RE: Raven Service Bulletin No. 113

INSTALLATION OF "PUSH-CHECKS" IN HP-II BURNER PRESSURE GAUGES

NOTE: This service bulletin applies to ALL Raven HP-II 12 million Btu burners shipped prior to November 3, 1981. The HP-II burner is characterized by the "S" coil nozzle, 1/2" stainless steel tubing, and a watertight base tray with rounded corners, in which the pressure gauge is mounted. A drawing of the HP-II burner is attached.

FIGURE #1

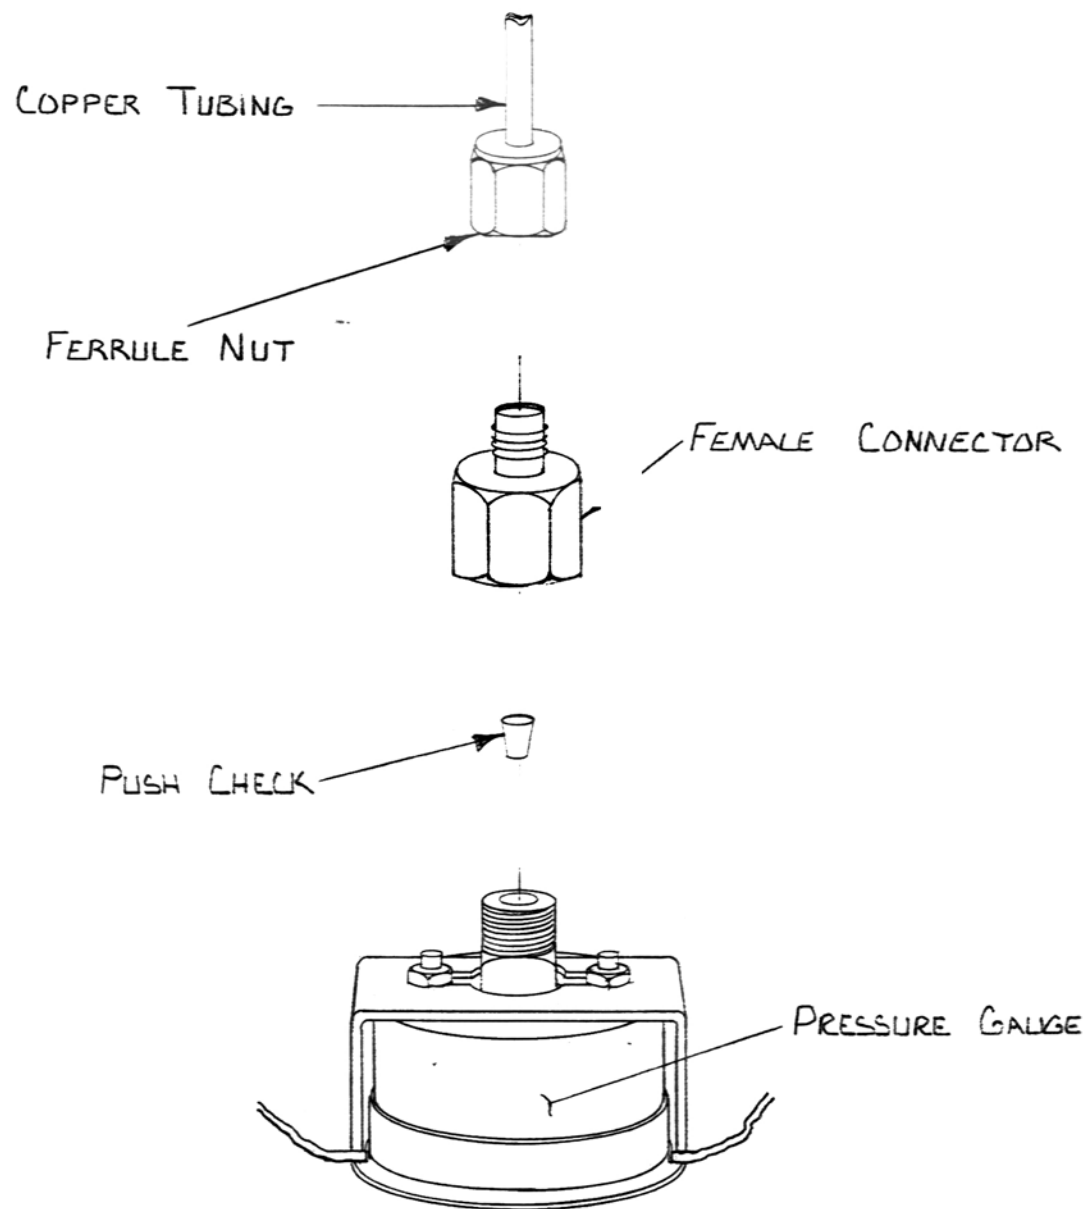
The gauge manufacturer has provided us with tiny brass thimbles which are to be installed in the gauges. These thimbles are called "push-checks" and are to be pressed into the back of the pressure gauges as shown in Figure 1 of this service bulletin. The push-checks have a very small hole in them (.006"), made by a laser beam, which will allow only enough propane movement

NOTE: Refer to Figure 1 (attached) for component location and identification.

2. Remove the female connector by using a 9/16" socket and extension.
 3. Position the push-check on the fuel inlet of the gauge as shown in Figure 1. Next, the push-check is to be driven into the inlet. A 1/8" drive punch may be used, but smaller diameter punches must not be used, since these may damage the push-check and defeat its purpose. A proven method is to place the snap-on end of a socket drive extension directly atop the push-check, and then tap lightly on the socket end using a small hammer. The push-check must be at least flush with the top of the opening when installed, and may be slightly recessed (up to about 1/16").
